Access Compliance Report Public Rights-of-Way (Curb Ramps)

Main Street: HICKORY_BRANCH_RD Cross Street: HICKORY_BRANCH_RD Location: SW

ADA ID: RPAT211008142919 Ramp Type: Type 4 - Parallel Initial Pass/Fail: Fail Overall Compliance: No Severity Score: 16

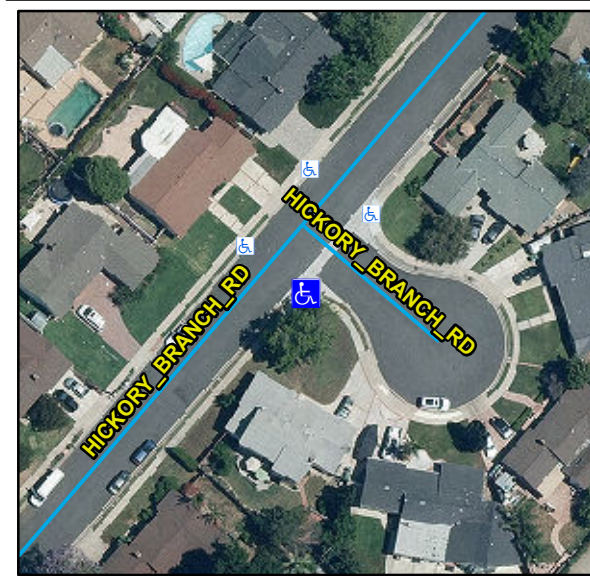
OC Std/PROW:
R304.3.2, R304.5.3, STD 1115

Compliance	Description	Data	Compliance	Description	Data
N/A	Ramp Length LT (in)	88	N/A	Ramp Length RT (in)	87
Yes	Ramp Width LT (in)	71	Yes	Ramp Width RT (in)	72
No	Ramp Run Slope LT (%)	8.6	Yes	Ramp Run Slope RT (%)	6.9
Yes	Ramp Cross Slope LT (%)	1.9	No	Ramp Cross Slope RT (%)	3.7
N/A	Landing Present	N/A	N/A	DWS Provided	N/A
N/A	Landing Length (in)	N/A	N/A	DWS Contrast	N/A
N/A	Landing Width (in)	N/A	N/A	DWS Length (in)	N/A
N/A	Landing Run Slope (%)	N/A	N/A	DWS Full Width	N/A
N/A	Landing Cross Slope (%)	N/A		DWS Offset Type	N/A
N/A	Landing Movement Obstructed?	N/A	N/A	DWS Offset Left (in)	N/A
	Landing Movement Type	N/A	N/A	DWS Offset Right (in)	N/A
N/A	Landing Shared	N/A			
N/A	Clear Space	Yes			
N/A	Clear Space To Crosswalk (in)	N/A			
N/A	Marked Crosswalk 1	No	N/A	Marked Crosswalk 2	No
	Crossing 1 Direction	E		Crossing 2 Direction	N
	Marked Crosswalk 1 Width (in)	N/A		Marked Crosswalk 2 Width (in)	N/A
N/A	Ramp Inside Crosswalk 1	N/A	N/A	Ramp Inside Crosswalk 2	N/A

Possible Solutions:
Remove & Replace Curb Ramp With Two New Directional Ramps or Equivalent.
